P802.1ASdm/D1.4 December 7, 2023

Draft Standard for Local and metropolitan area networks—

Timing and Synchronization for Time-Sensitive Applications

Amendment: Hot Standby

Figure 7-7—Model for PTP Instance and its interfaces to higher-layer applications model

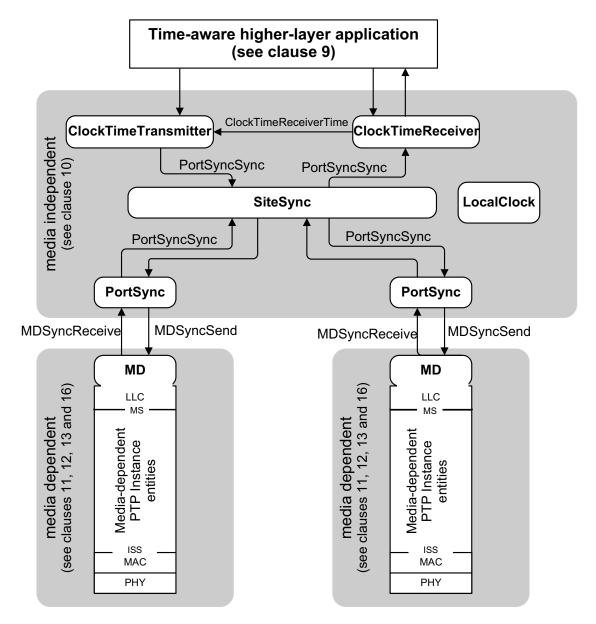
Change the first paragraph of 7.4 and the caption of Figure 7-8 as follows:

The model of a PTP Instance <u>and its interfaces to higher-layer applications are is</u> shown in Figure 7-7. <u>The interfaces are those specified in Clause 9.</u>

Figure 10-2—Time-synchronization state machines—overview and interrelationships

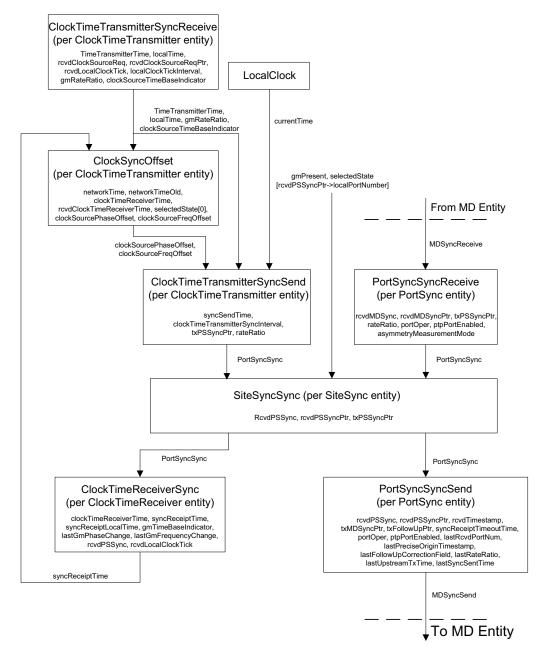
Change 10.2.1 and Figure 10-2 as follows:

Figure 10-6—ClockTimeTransmitterSyncOffset state machine

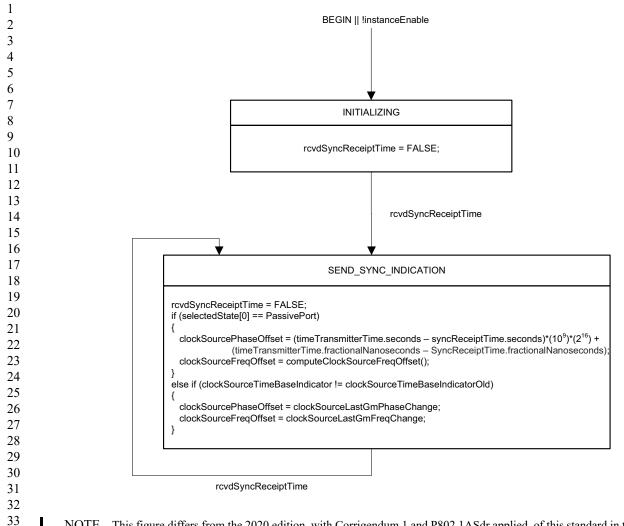
Replace Figure 10-6 with the following:

NOTE—This figure differs from the 2020 edition, with Corrigendum 1 and P802.1ASdr applied, of this standard in that the statement clockSourcePhaseOffset = timeTransmitterTime.seconds – syncReceiptTime; in the SEND_SYNC_INDICATION state is replaced by clockSourcePhaseOffset = (timeTransmitterTime.seconds – syncReceiptTime.seconds)*(10⁹)*(2¹⁶) + (timeTransmitterTime.fractionalNanoseconds – SyncReceiptTime.fractionalNanoseconds);

Figure 10-16—PortAnnounceInformationExt state machine

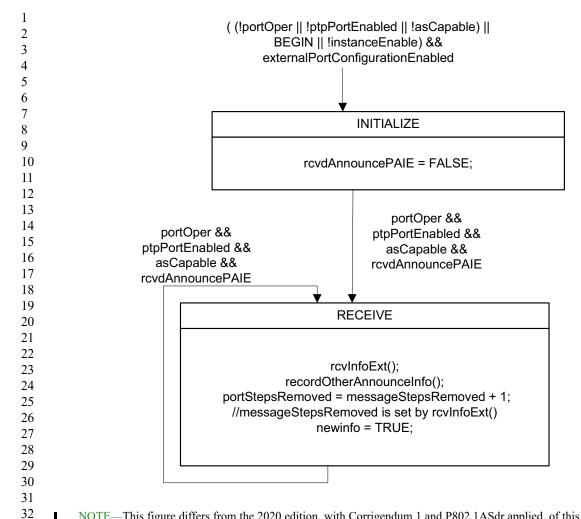
Change 10.3.14.3 as follows:

NOTE—This figure differs from the 2020 edition, with Corrigendum 1 and P802.1ASdr applied, of this standard in that the statement newinfo = TRUE; is added after the existing statements in the RECEIVE state.

Figure 10-17—PortStateSettingExt state machine

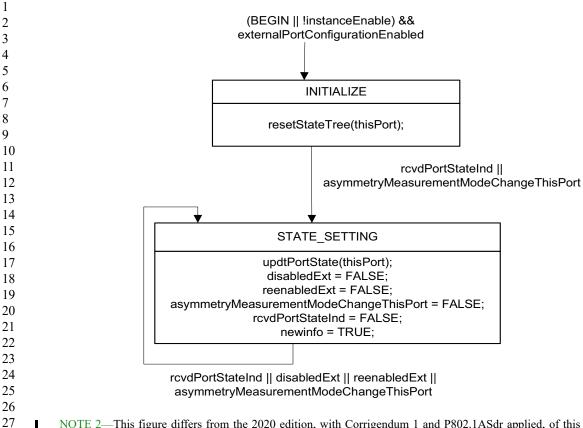
NOTE 2—This figure differs from the 2020 edition, with Corrigendum 1 and P802.1ASdr applied, of this standard in that the statement newinfo = TRUE; is added after the existing statements in the STATE SETTING state.

Figure 10-18—PortAnnounceTransmit state machine

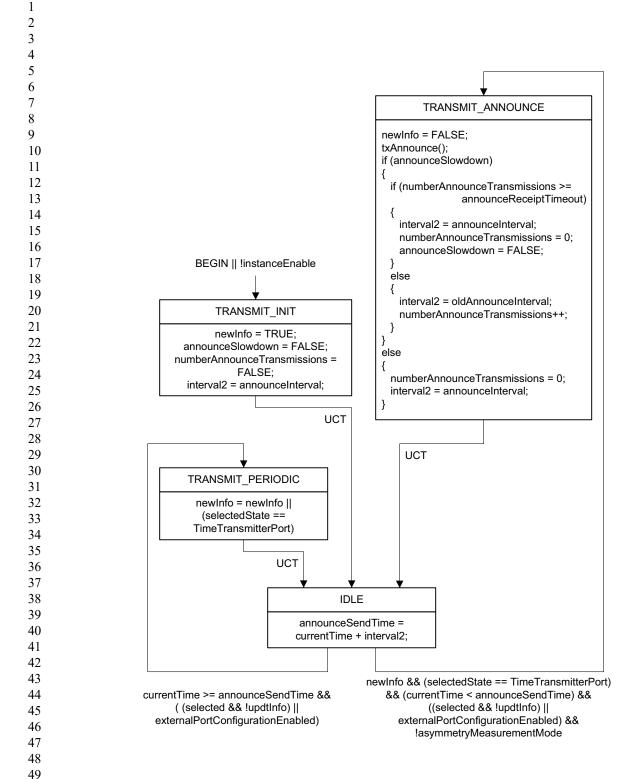
Replace Figure 10-18 with the following:

NOTE 2—This figure differs from the 2020 edition, with Corrigendum 1 and P802.1ASdr applied, of this standard in that the statement interval = announceInterval is added after the existing statements in the TRANSMIT INIT state.

Figure 10-19—AnnounceIntervalSetting state machine

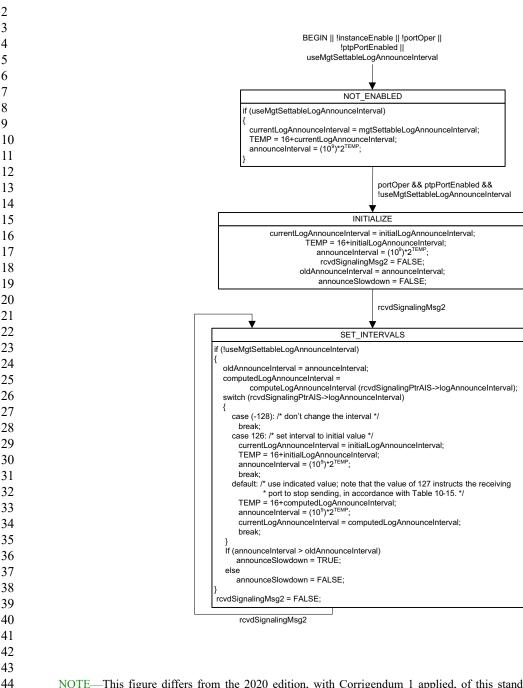
Replace Figure 10-19 with the following:

NOTE—This figure differs from the 2020 edition, with Corrigendum 1 applied, of this standard in that the variable LogAnnounceInterval at the end of line 5 of the SET INTERVALS state is changed to logAnnounceInterval (i.e., the capitalization is corrected), and the statement oldAnnounceInterval = announceInterval is added immediately after the first open curly brace in the SET_INTERVALS state.

Figure 11-6—MDSyncReceiveSM state machine

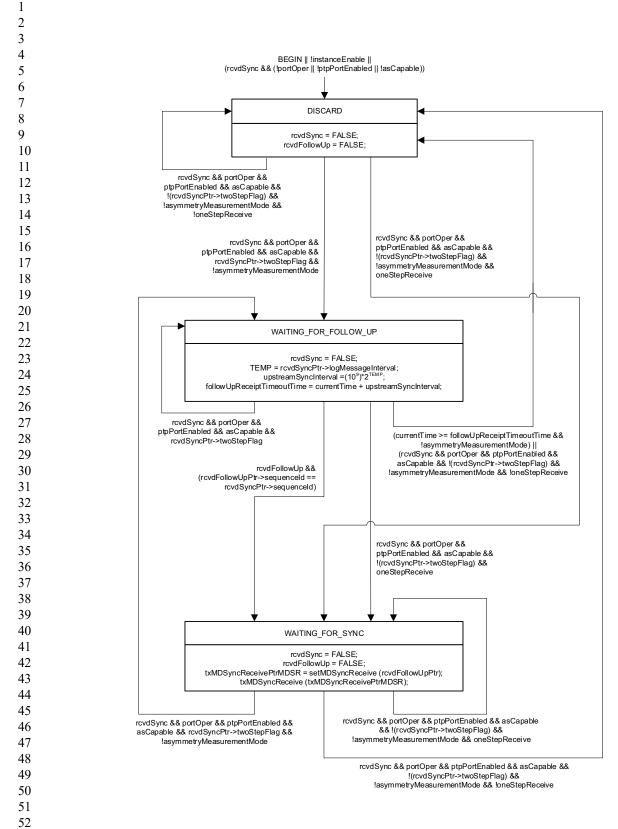
Replace Figure 11-6 with the following:

<u>NOTE</u>—This figure differs from the 2020 edition, with Corrigendum 1 applied, of this standard in that the variable portEnabledOper at the entry to the DISCARD state is changed to portOper.

Figure 11-7—MDSyncSendSM state machine

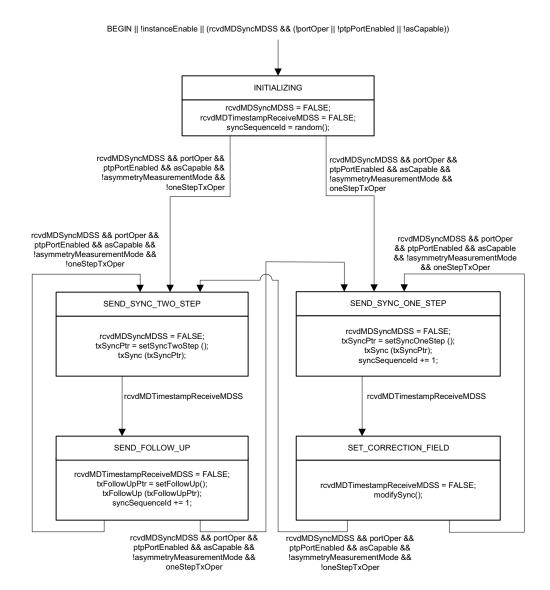
Replace Figure 11-7 with the following:

NOTE—This figure differs from the 2020 edition, with Corrigendum 1 applied, of this standard in that (a) the variable portEnabledOper is changed to portOper on the links between the SEND_FOLLOW_UP and SEND_SYNC_TWO_STEP states, between the SEND_FOLLOW_UP and SEND_SYNC_ONE_STEP states, and between the SET_CORRECTION_FIELD and SEND_SYNC_TWO_STEP states; and (b) the statement 'syncSequenceId += ' in the last line of the SEND_SYNC_TWO_STEP state is moved to the last line of the SEND_FOLLOW UP state.

Figure 11-9—MDPdelayReq state machine

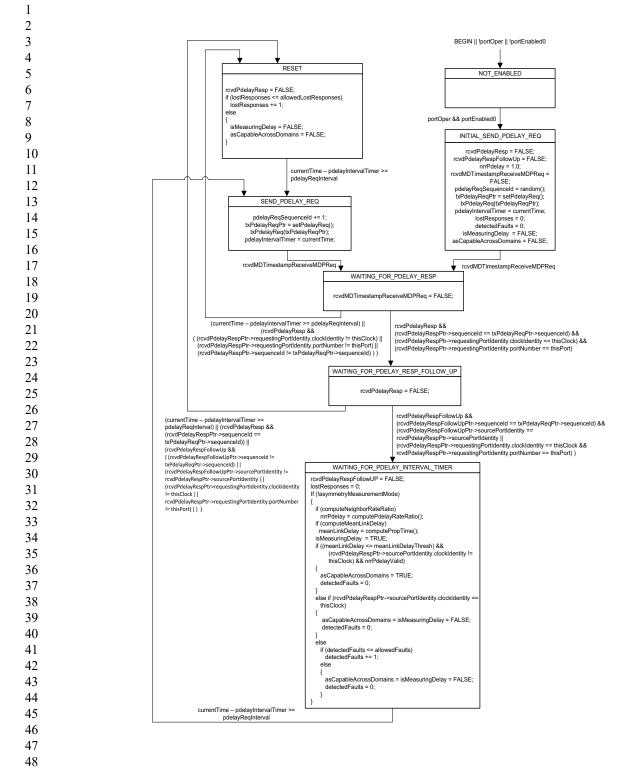
Replace Figure 11-9 with the following:

Delete the NOTE immediately after Figure 11-9.

NOTE—This figure differs from the 2020 edition, with Corrigendum 1 applied, of this standard in that (a) the condition "else if (rcvdPdelayRespPtr->sourcePortIdentity.clockIdentity != thisClock)" in the state WAITING_FOR_PDELAY_INTERVAL_TIMER is changed to "else if (rcvdPdelayRespPtr->sourcePortIdentity.clockIdentity == thisClock)" (i.e., "!=" is changed to "=="), and (b) the variables neighborRateRatio and neighborRateRatioValid are replaced by nrrPdelay and nrrPdelayValid, respectively.

Figure 17-1—Overview of YANG tree

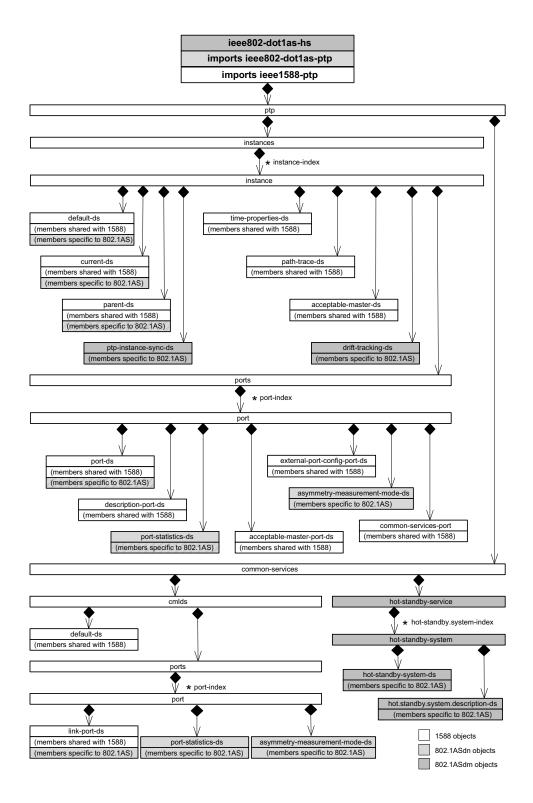
Replace Figure 17-1 with the following:

NOTE 1—This figure differs from the 2020 edition of this standard with Corrigendum 1 applied and as amended by IEEE Std 802.1ASdn in that managed objects needed for the hot standby and Drift_Tracking TLV features are added.

Figure 17-2—PTP Instance detail

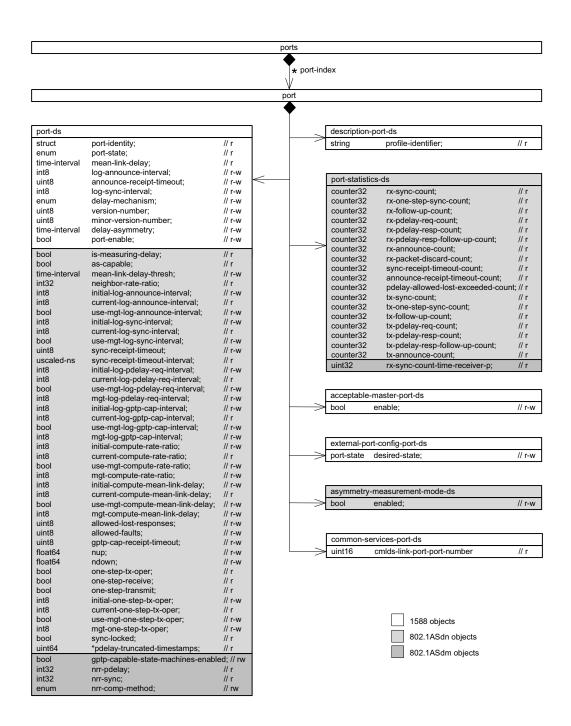
NOTE 2—This figure differs from the 2020 edition of this standard with Corrigendum 1 applied and as amended by IEEE Std 802.1ASdn in that managed objects needed for the hot standby and Drift_Tracking TLV features are added.

Figure 17-4—Common services detail

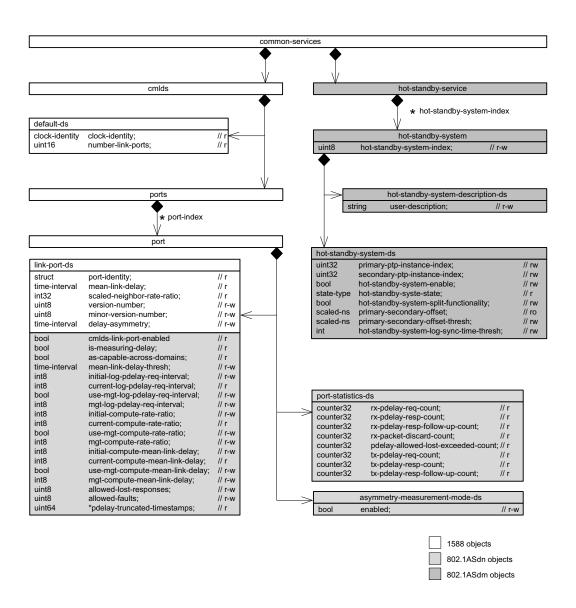
Replace Figure with the following:

NOTE 4—This figure differs from the 2020 edition of this standard with Corrigendum 1 applied and as amended by IEEE Std 802.1ASdn in that managed objects needed for the hot standby and Drift Tracking TLV features are added.
